Name Of Dam: SPORTSMEN'S CLUB DAM

Inventory Number: VA 18502

# PHASE I INSPECTION REPORT

## NATIONAL DAM SAFETY PROGRAM

PRINCIPAL SPILLWAY - NOTE LEAKAGE OVER WING WALL  
AT LEFT AND EROSION OF SOIL AT END OF BOTH WING WALLS

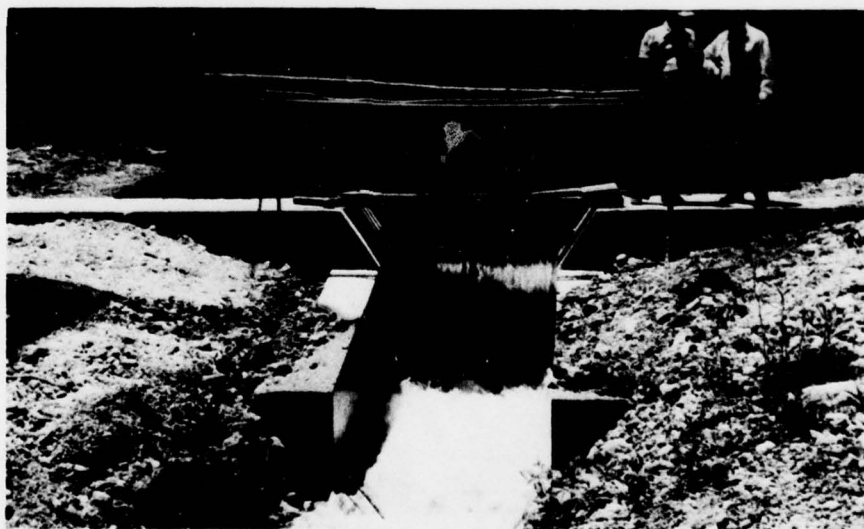
c. There is about 5 g.p.m. leakage emerging at the top of the downstream right wall of the principal spillway. It is not critical under the normal-pool condition because of the low head of water at the location and gently sloping right abutment. However, during a flood condition, the leakage can seriously undermine the wall foundation.

c. The leakage at the spillway wall should be repaired.

RIPRAP ON UPSTREAM SLOPE OF DAM  
(NOTE: NORMAL WATER LEVEL WAS HIGHER PRIOR TO USE OF  
PRINCIPAL SPILLWAY)

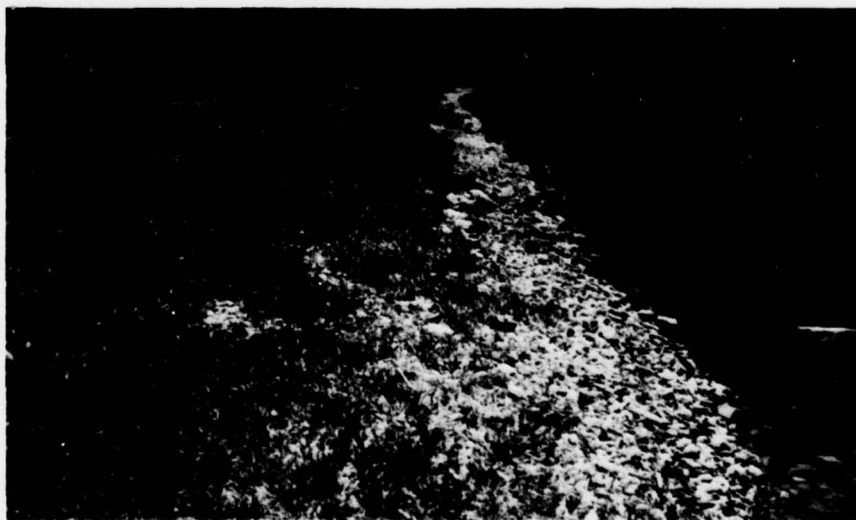
Minor erosion was observed on the upstream slope along the upper boundary line of the riprap; that is, approximately 6 feet below the top of the dam, measured along the slope. No other sign of distress was observed on the upstream slope.

b. Eroded areas should be protected with adequately sized riprap.
